**REQUEST**

Current Zoning: R-3 (single family residential)  
Proposed Zoning: I-1(CD) (light industrial, conditional) and  
MUDD(CD) (mixed use development, conditional)

**SUMMARY OF PETITION**

### • Proposed Request Details

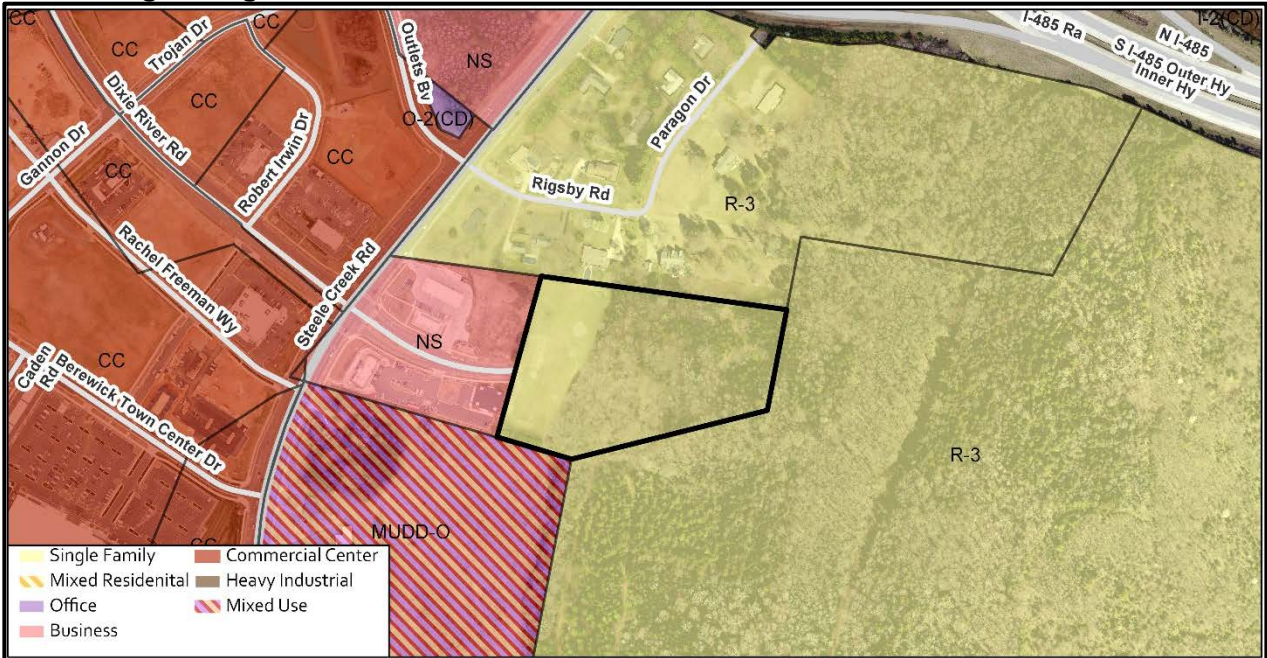
1. Update the site plan conditional note(s) to commit to install 25 mile-per-hour MUTCD signs on the new public streets.

2. MUDD areas will be required to provide 15% tree save area onsite. Show tree save area on site map. Tree save area must be 30 feet minimum width. Must contain existing healthy trees.
